RE: 3301 Candelaria NE
Grading Plan Engineer's Stamp Date: 11/15/19
Hydrology File: G16D097

Based on the submittal received on 11/19/19, the Grading and Drainage Plan is approved for Building Permit, and SO-19.

GRADING & DRAINAGE PLAN
3301 CANDELARIA ROAD NE
ALBUQUERQUE, NM 87107
NOVEMBER 15, 2019

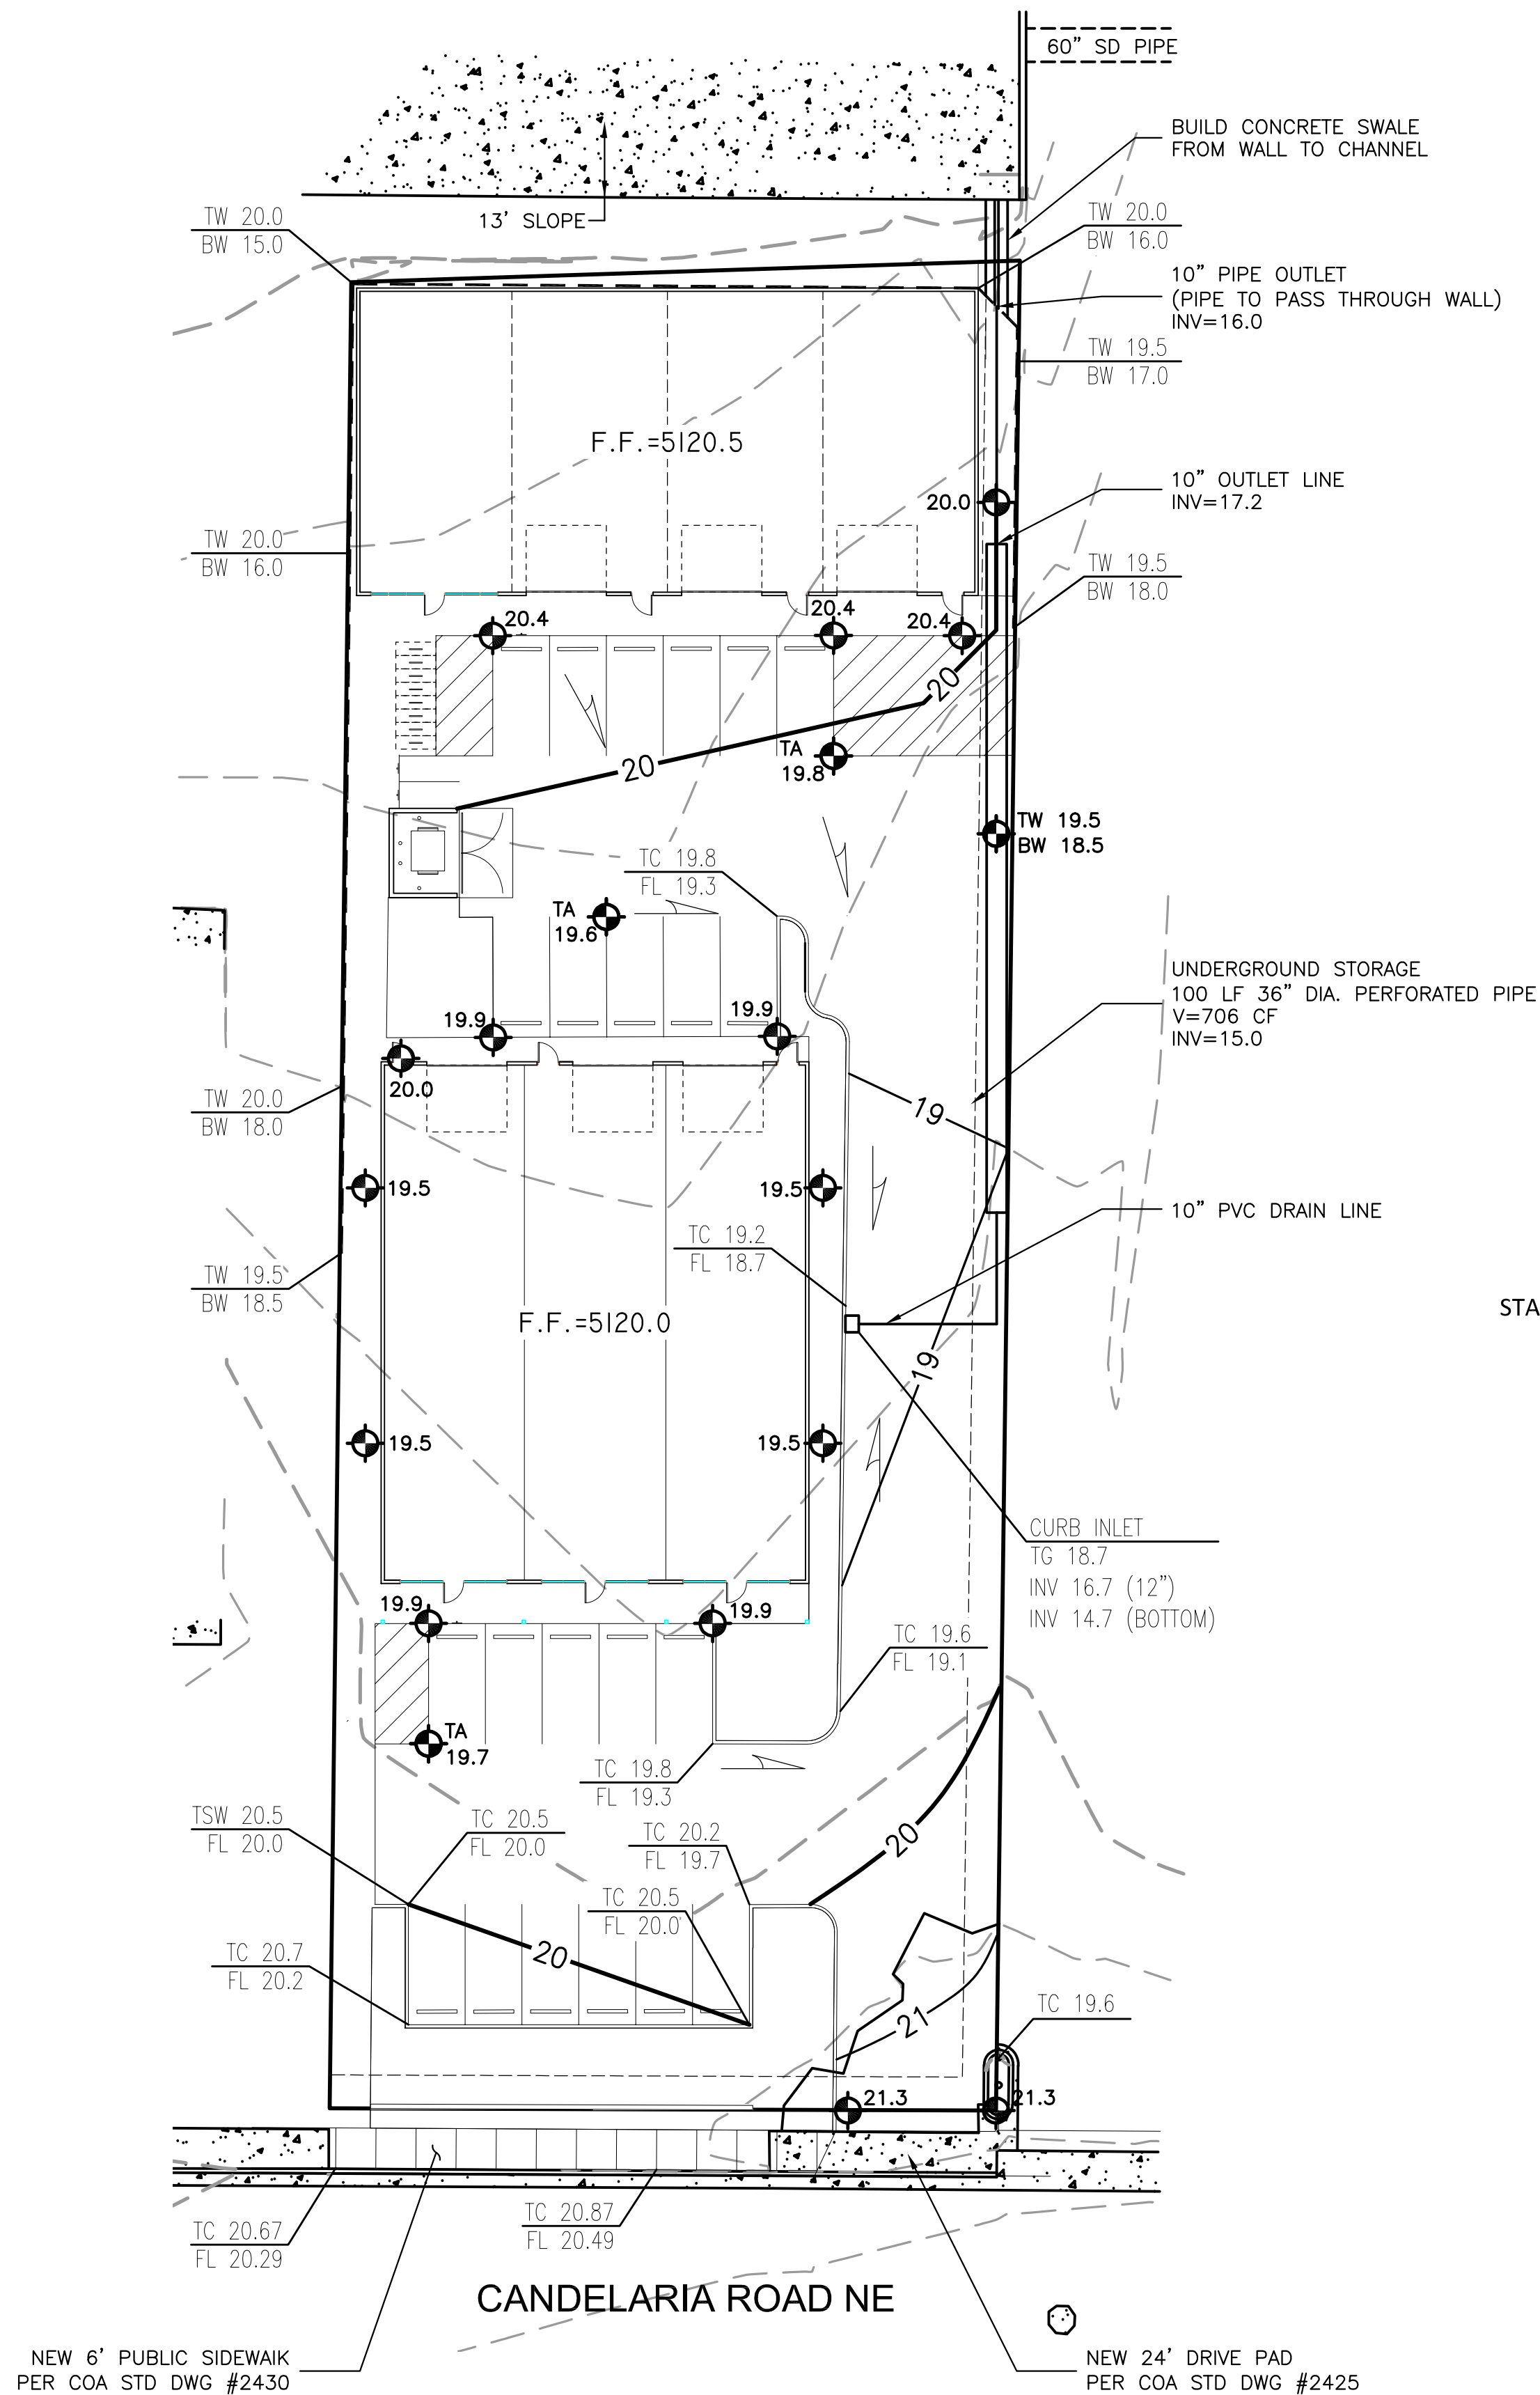
2. A Bernalillo County Recorded [Drainage Covenant \(No Public Easement\)](#) is required for the underground stormwater pond. The original notarized form, exhibit A (legible on 8.5x11 paper), and recording fee (\$25, payable to Bernalillo County) must be turned into DRC (4th, Plaza del Sol) for routing. Please contact Charlotte LaBadie (clabadie@cabq.gov, 924-3996) regarding the routing and recording process for covenants. The routing and recording process for covenants can take a month or longer; Hydrology recommends beginning this process as soon as possible as to not delay approval for certificate of occupancy.

3. The concrete swale must be inspected and approved by Storm Drain Maintenance (Augie Armijo at (505) 857-8607).
